FPL Energy
Seabrook Station

NYN-03080

Seabrook Station
Revision to Inservice Test Program Relief Request PR-3

ENCLOSURE TO NYN-03080

Figure 1
CBS-P-9-B Pump Outboard Bearing Horizontal Vibration Spectra

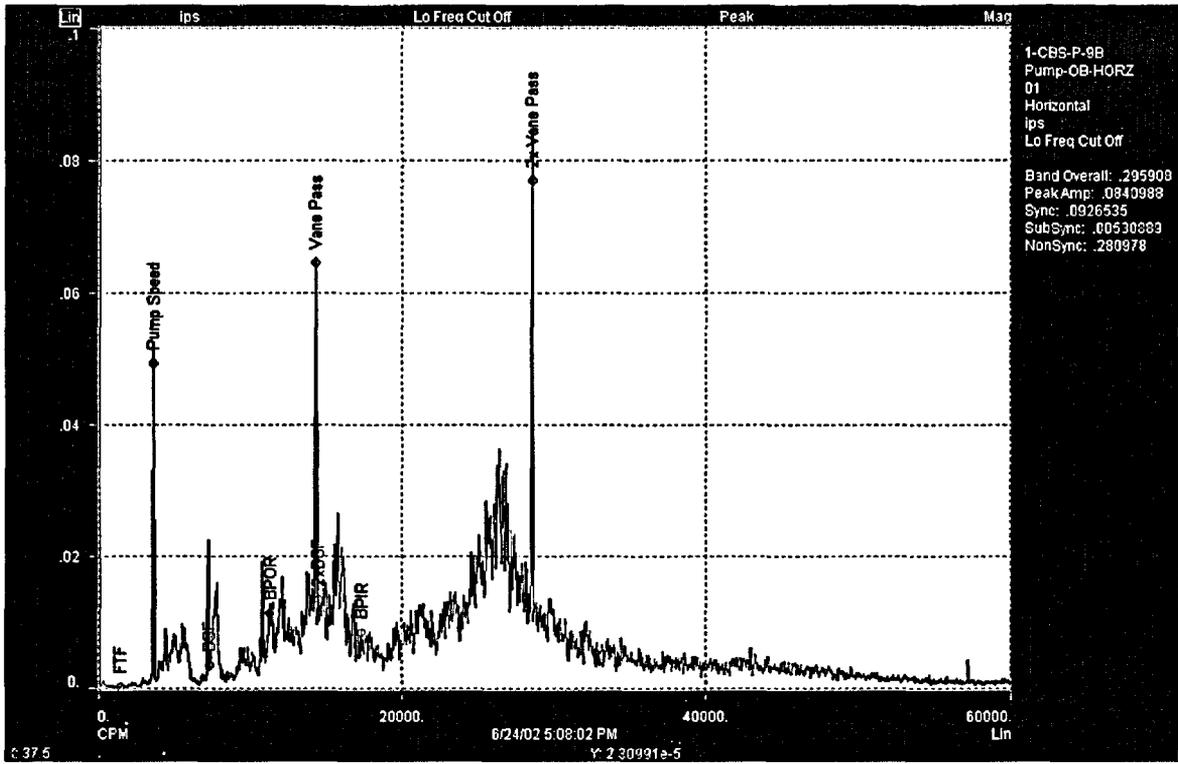
During routine pump surveillance testing both vibration amplitude and spectral data are collected. Pump and motor spectral data are reviewed and trended over a frequency range of 5 to 1000 Hz. This data indicates that there are no pump rolling element bearing or motor bearing degrading trends. The pump vibration spectrum does contain several upper energy spectral peaks at four and eight times running speed. See Figure 1 CBS-P-9B Pump Outboard Bearing Horizontal Vibration Spectra below.

Pump bearing housing modal testing identified broad resonance amplification peaks at the pump 1x and 2x vane pass frequencies. Vibration spectral analysis shows that the pump outboard bearing horizontal location has a 1x amplitude peak of 0.05 ips, while the vane pass amplitude peak is 0.065 ips and the two time vane pass amplitude is 0.084 ips. This data supports that the elevated vibration amplitudes at the pump outboard bearing are the result of vane pass excitation energy due to resonance amplified. Data analysis has not identified any bearing distress frequencies or indications of improper rotor balance or shaft rubs.

Figure 2
CBS-P-9-A Pump Outboard Bearing Horizontal Vibration Spectra

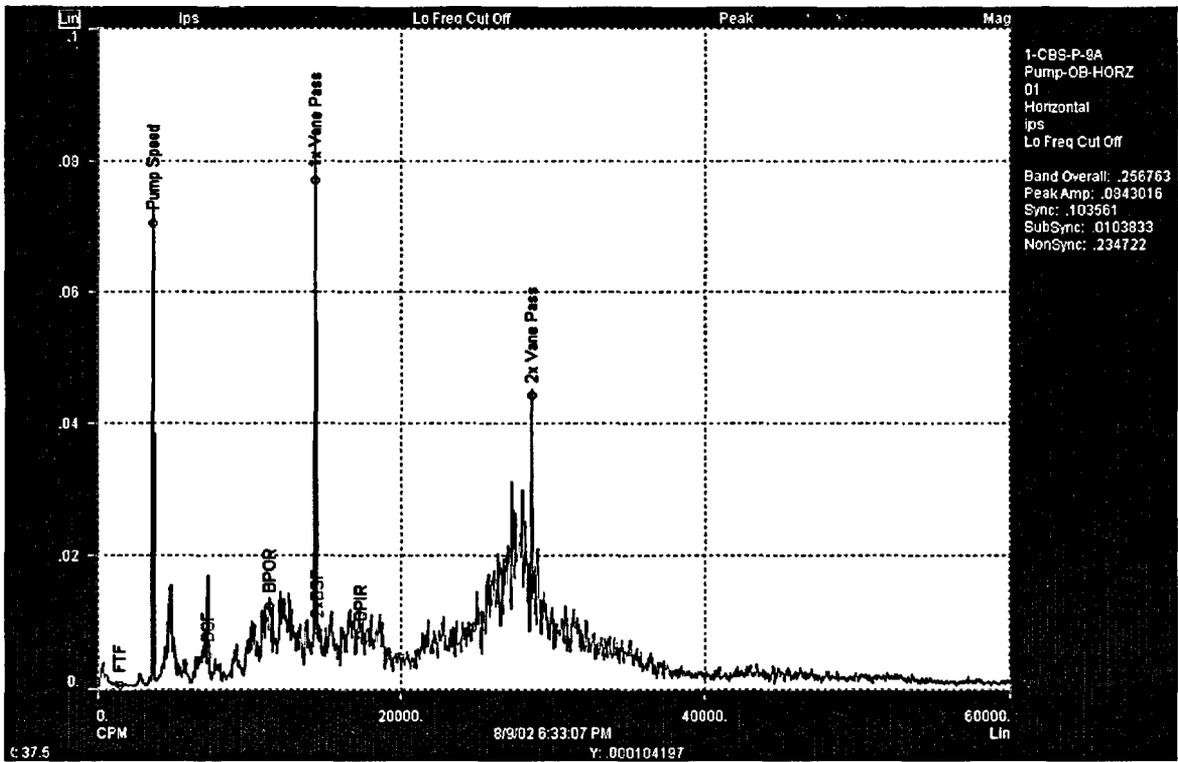
Pump bearing housing resonance amplification problem is also present on CBS-P-9-A, but to a lesser degree. See Figure 2, CBS-P-9A Pump Outboard Bearing Horizontal Vibration Spectra. Pump outboard vibration amplitudes are averaging 0.31 ips.
